## BID ADDENDUM #1

Nanuet Union Free School District  
103 Church Street  
Nanuet, NY 10954

*Nanuet Bond Projects Phase 3*

**Date: June 22, 2023**

**SHEET NAME:**  
 LOWER LEVEL FLOOR PLAN AND ENLARGED ELEVATOR PLANS

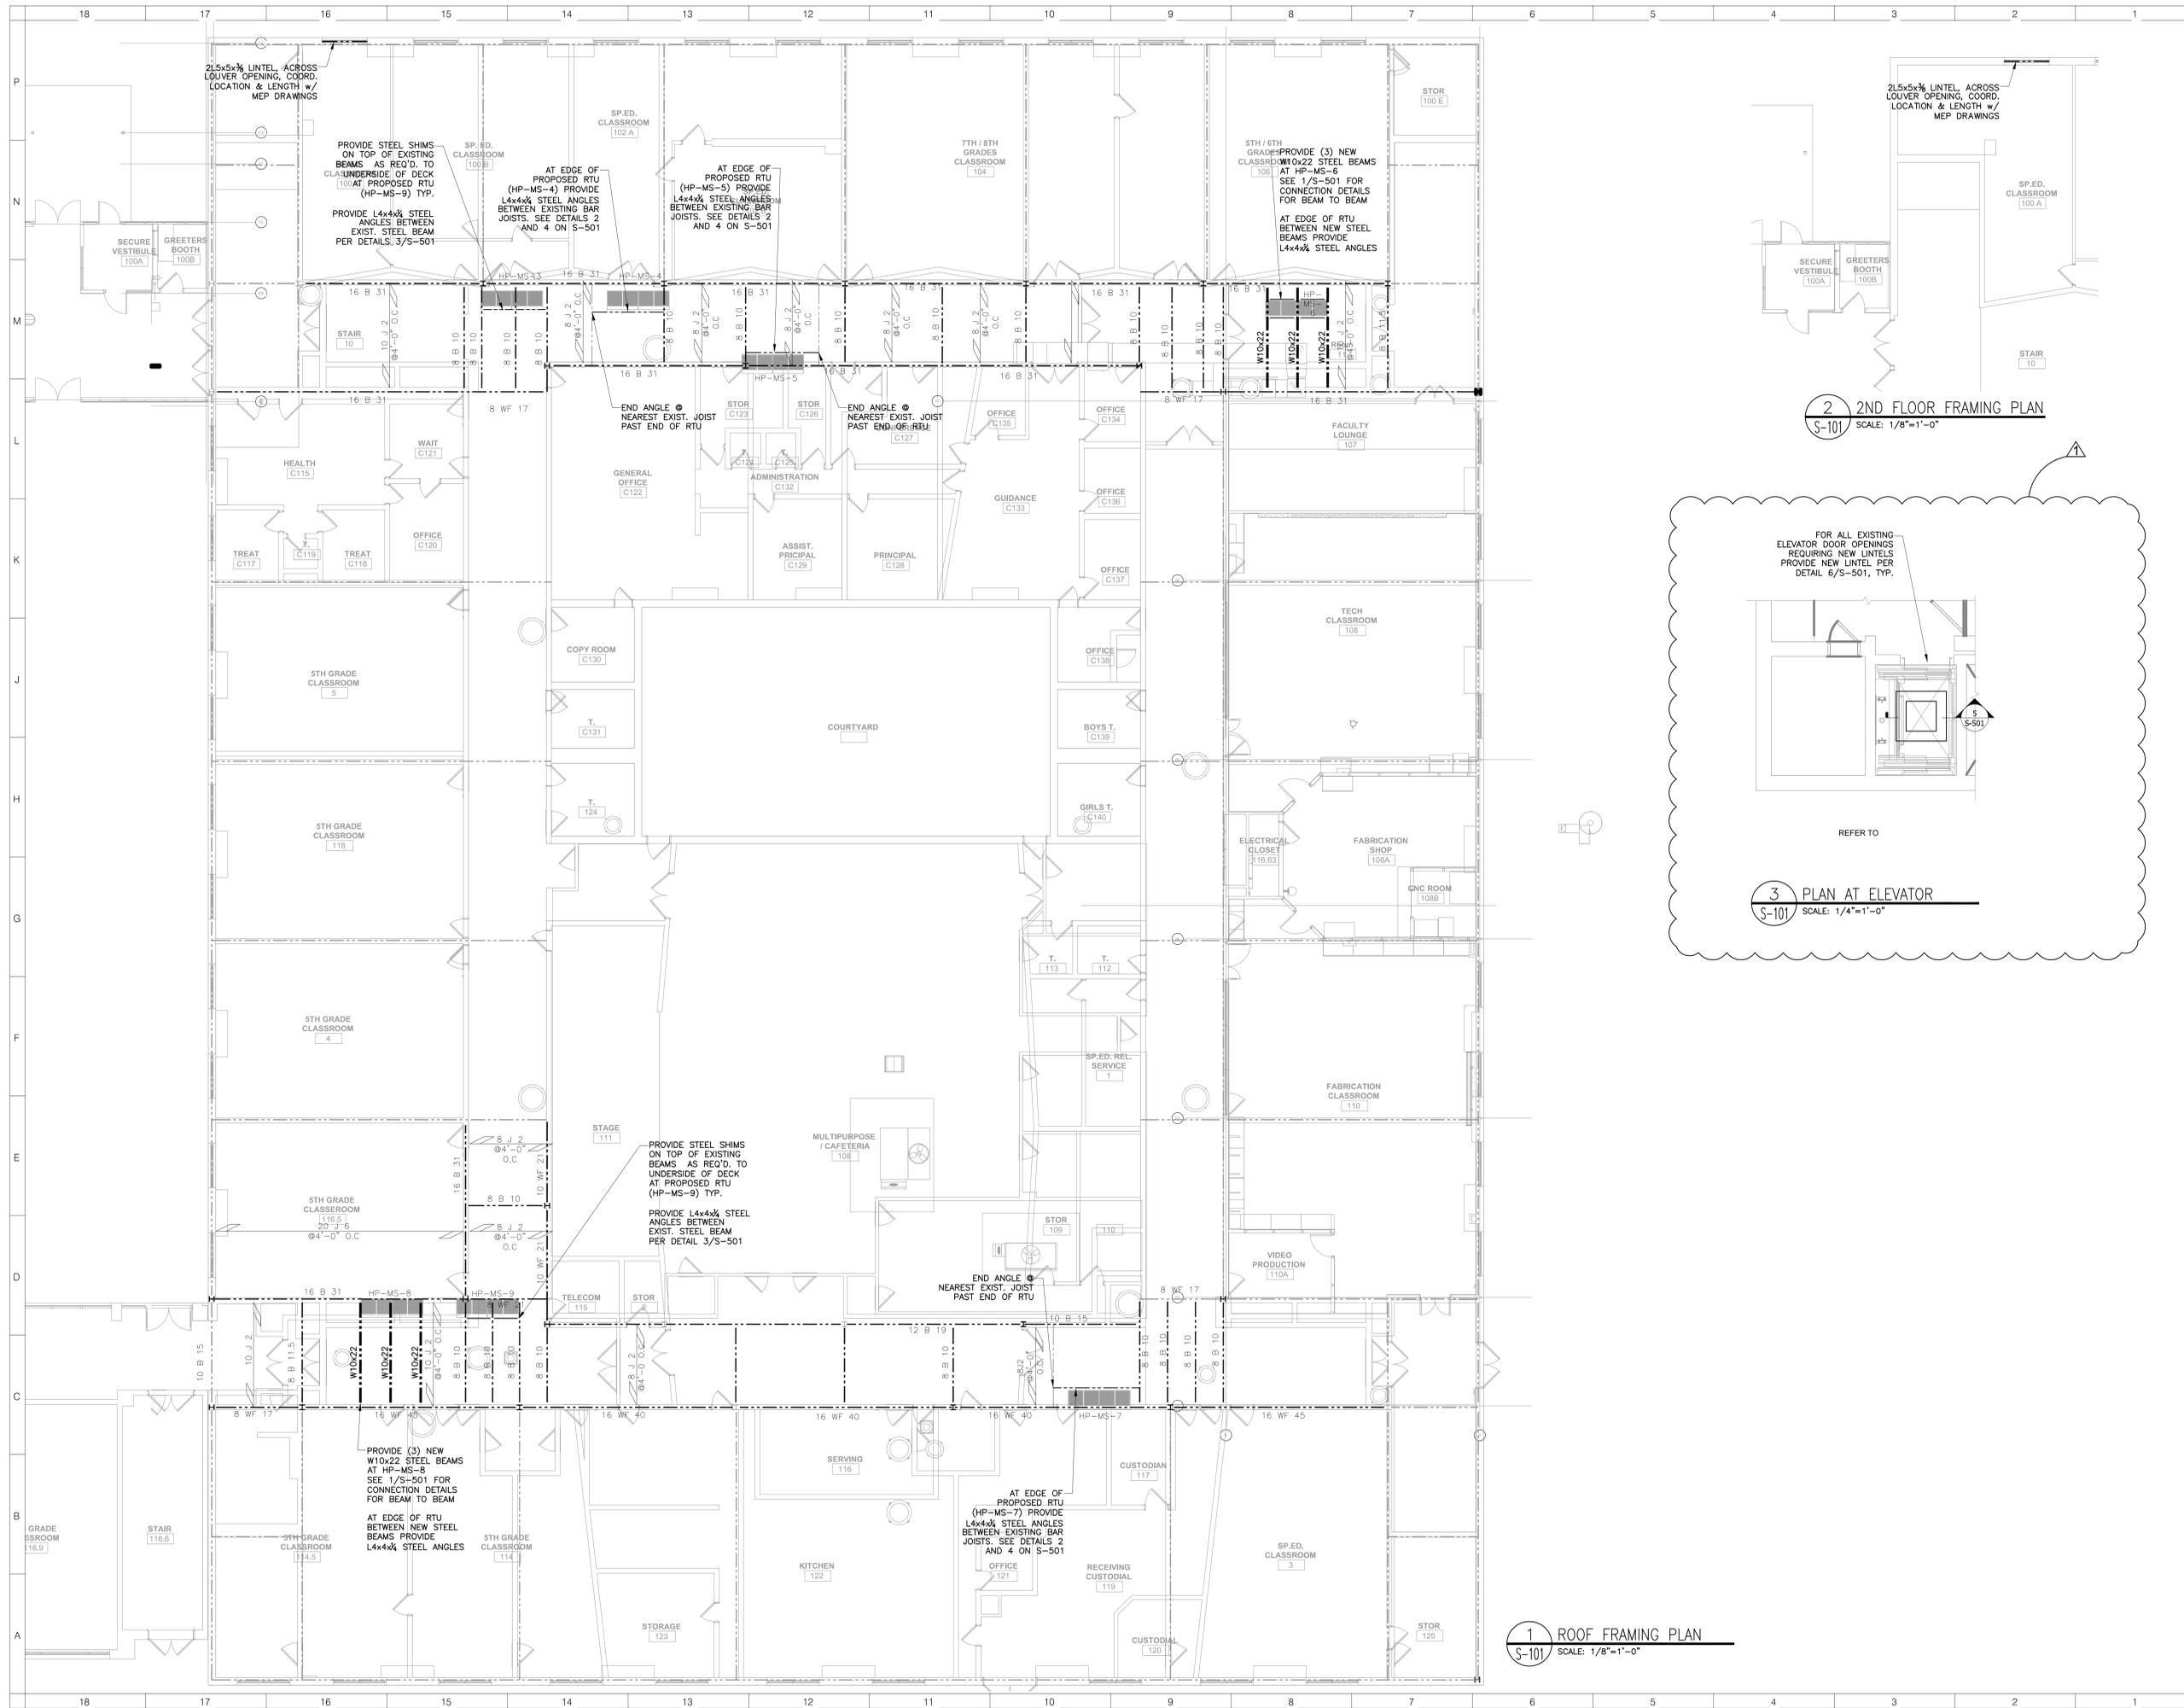
**Response:** The 4" hot water supply and return piping shown on drawing HS-M107 continue on drawing HS-M108 boiler room plan detail A9.
3. The elevator replacement drawings call for the new elevator to be Elvoron by Garaventa Lift. But the specs call for Lula Elevator by Symmetry. Elvoron elevator will not fit in the existing shaft. Please clarify which spec to follow.

**Response:** Refer to spec SECTION 14 26 00 – LIMITED USE/APPLICATION HYDRAULIC ELEVATOR. Provide Limited Use/Limited Application (LU/LA) Hydraulic Passenger Elevator by Symmetry

**ISSUED: BID SET ISSUANCE**  
**DATE:** 6/6/2023  
**SCALE:** AS SHOWN  
**SHEET NAME:** STRUCTURAL PLANS  
**SHEET NUMBER:** MS-S101

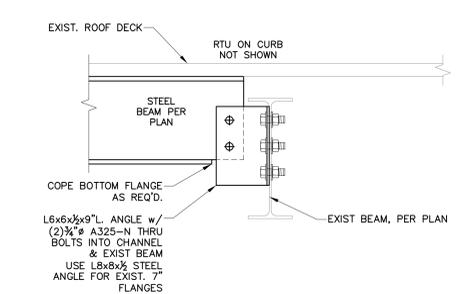
No.	Description	Date
1	BID ADDENDUM #1	6/22/2023
